County Project No. C21901

**Subject: Responses to Questions for Public Circulation of Asti Permanent Bridge Construction Project over the Russian River IS-MND**

Figure - 1 Parcel Locations

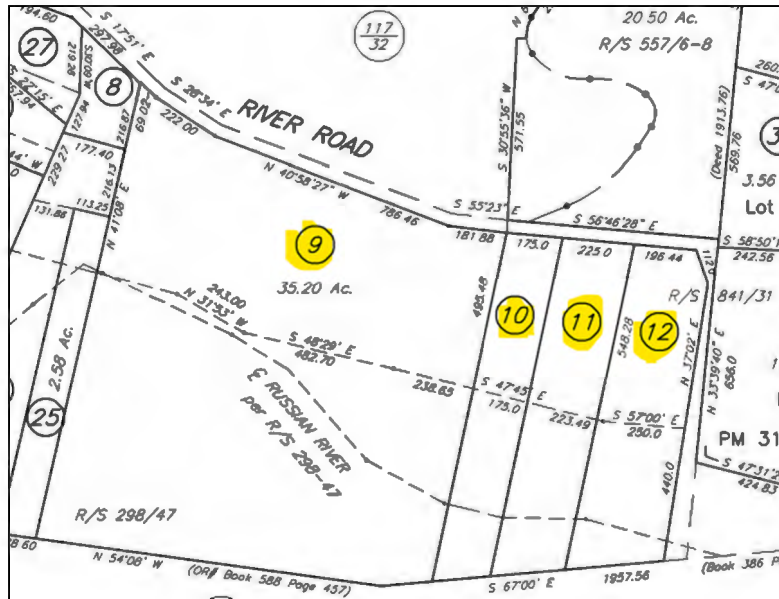
- a. *“We are concerned that the levee and the retaining wall on the parcel South of us (will) cause the water to back up onto our properties. This is the parcel where the bridge will be placed. In the IS/MND more retaining walls are discussed. Where will they be and will they cause more water to back-up onto our properties?”*

- b. *“During the winter months of 2023/24 with all of the gravel movement in the river another island appears to be forming at the same location as the temporary bridge. If this continues to build up will this cause more flooding on our properties?”*

- c. *“It is a major concern that a bridge with new foundations in the river and the proposed retaining walls will cause even more changes to the flow of the river causing potential flooding on our properties.”*

Response – The existing wall and levee on the Sciami property would remain. A new retaining wall would also be constructed along the bridge approach along Washington School Road. Because the project would open up the river channel, reduce constrictions and increase the clear area for water passage in the river, these features and the project would not cause more water to back up onto your parcels. This was verified in the hydraulic models discussed below. Please refer to the section below titled “HEC-RAS River Analysis – Existing Condition/Post Project Condition.

Response – With the existing seasonal crossing removed, the river channel would be less constricted (as described above), which should reduce the buildup of

Response – As discussed in responses a and b above, the proposed bridge project would remove the seasonal crossing and open up the channel as described above, which would reduce water surface elevations upstream of the bridge and maintain water surface elevations downstream of the bridge when compared to the existing condition. Please refer to the section below titled “HEC-RAS River Analysis – Existing Condition / Post Project Condition.”

Figure 10

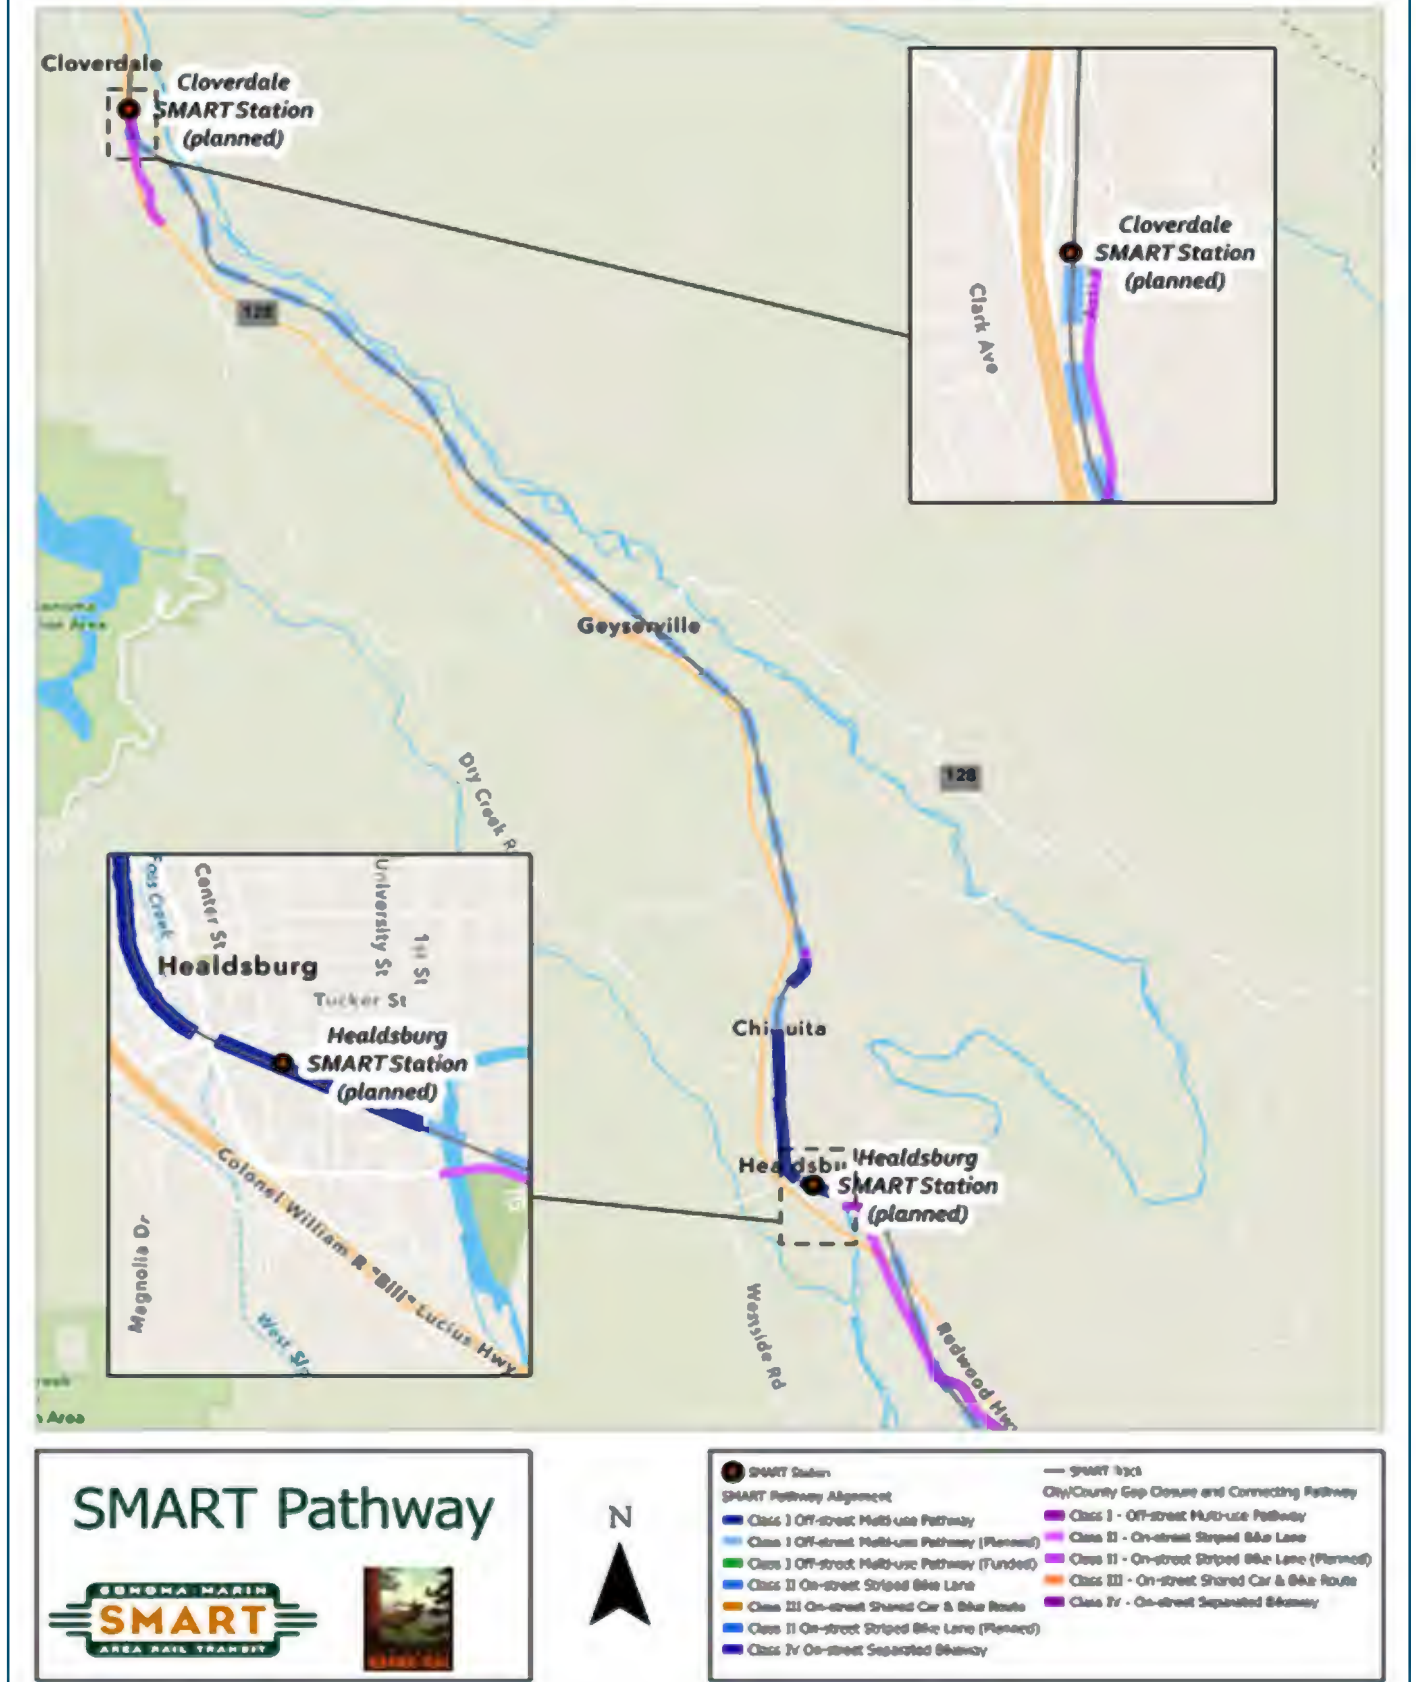
*Question – Please indicate the expected speed on the bridge. If the expected speed on the bridge would be in the lower range of 30-40 miles per hour, a vertical separation between the bike lanes and vehicular travel lanes would be recommended to reduce level of traffic stress for cyclists.*

- The Sonoma County Bicycle and Pedestrian Plan website, which can be found here: (<https://www.permitsonoma.com/longrangeplans/adoptedlong-rangeplans/bicycleandpedestrianplan>) indicates that a Class 1 bikeway is proposed along the Sonoma-Marín Area Rail Transit District (SMART) right of way (see Figure 10 further below) just south of the project limits and a Class 2 bike lane is proposed for Asti Road from Cloverdale to Healdsburg. These routes would be the preferred route for bicyclists riding along the Russian River. Providing a Class 1 bikeway across the bridge could encourage riders to travel over the new bridge to River Road, which is very narrow (9.5 foot lanes and 0 foot to 1 foot shoulders, see Figure 9 below) for cyclists.
